# **DEVELOPMENT APPLICATION ASSESSMENT REPORT**

Application Number:	DA2025/0026		
Responsible Officer:	Simon Ferguson Tuor		
Land to be developed (Address):	Lot 17 DP 30849, 17 Egan Place BEACON HILL NSW 2100		
Proposed Development:	Alterations and additions to a dwelling house including a swimming pool		
Zoning:	Warringah LEP2011 - Land zoned R2 Low Density Residential		
Development Permissible:	Yes		
Existing Use Rights:	No		
Consent Authority:	Northern Beaches Council		
Land and Environment Court Action:	n: No		
Applicant:	Timothy Stephen Burt		
Application Lodged:	22/01/2025		
Integrated Development:	No		
Designated Development:	No		
State Reporting Category:	Residential - Alterations and additions		
Notified:	06/02/2025 to 20/02/2025		
Advertised:	Not Advertised		
Submissions Received:	0		
Clause 4.6 Variation:	4.3 Height of buildings: 7.65%		
Recommendation:	Approval

Figure 1. Section (red highlighting height of buildings variation)

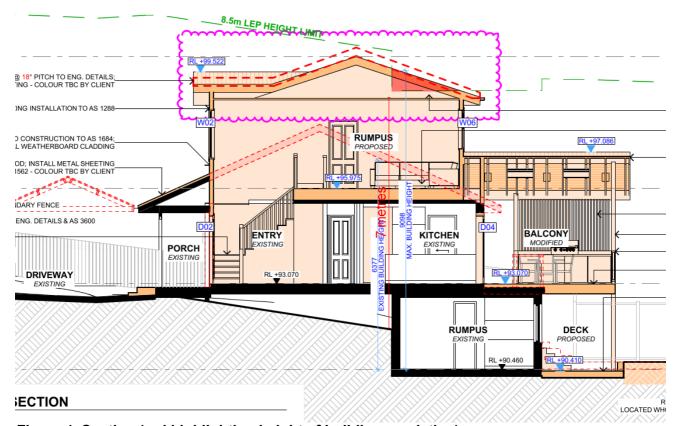
- The building height breach is minor and relates to only a small portion of the proposed addition only (Refer Figure 1), which will largely be indiscernible when viewed from Egan Place. It is important to acknowledge that breaching element will not be viewed from the street and the front of the dwelling is approximately 1.6m below the allowable height.

It is considered on balance, that having regard to the particular circumstances of Clause 4.3 Height of buildings that the proposed development is acceptable, noting the existing excavated rumpus area

contributes to the proposal presenting a height breach. It is considered that the breach is isolated to the portion directly above the existing rumpus area, and the variation is supportable in the circumstances of the existing site. As such, the proposed departure from the development standard is acceptable and it is reasonable that flexibility to the standard be applied.

Figure 2 - Extract from West Elevation with side boundary envelope encroachment in red.

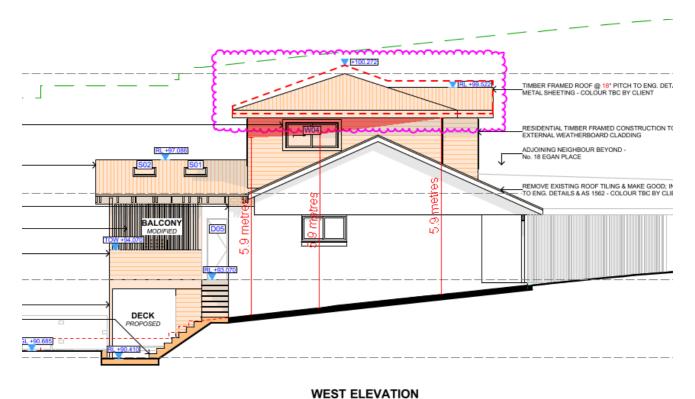
The proposed first floor addition presents an encroachment at the western elevation as shown in the figure below:

Having regard to the above assessment, it is concluded that the proposed development is consistent with the relevant objectives of WDCP and the objectives specified in s1.3 of the Environmental Planning and Assessment Act, 1979. Accordingly, this assessment finds that the proposal is supported, in this particular circumstance.

Figure 4 - Rear setback non-compliance shown in Blue.

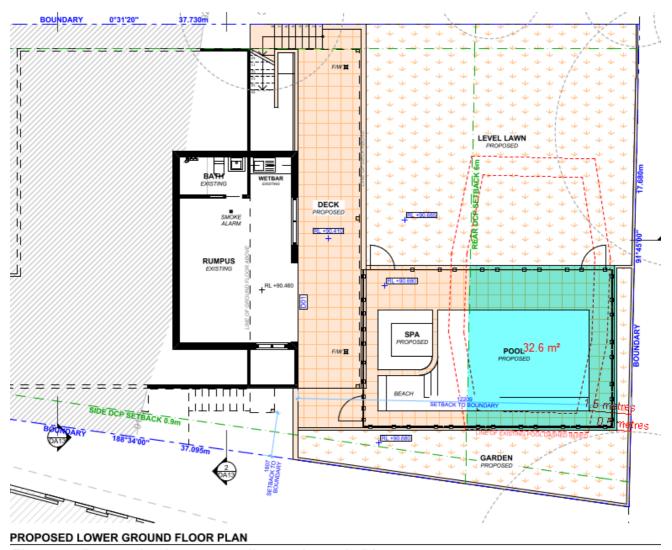
The proposed swimming pool and decking area encroaches within the rear setback but does not occupy more than 50% of the setback area, as displayed below:

The pool is generally sited in over the existing swimming pool footprint, yet provides an improved outcome in relation to landscaping and deep soil areas. As such, there are improved possibilities for the establishment of planting that is of a size and scale to screen the development from adjoining properties. In addition, the works are reasonably set back from adjoining buildings, which mitigates any unacceptable visual and aural privacy impacts. Therefore, the proposal has been designed appropriately to preserve neighbourhood amenity.

Having regard to the above assessment, it is concluded that the proposed development is consistent with the relevant objectives of WDCP and the objectives specified in section 1.3 of the Environmental Planning and Assessment Act, 1979. Accordingly, this assessment finds that the proposal is supported in this particular circumstance.
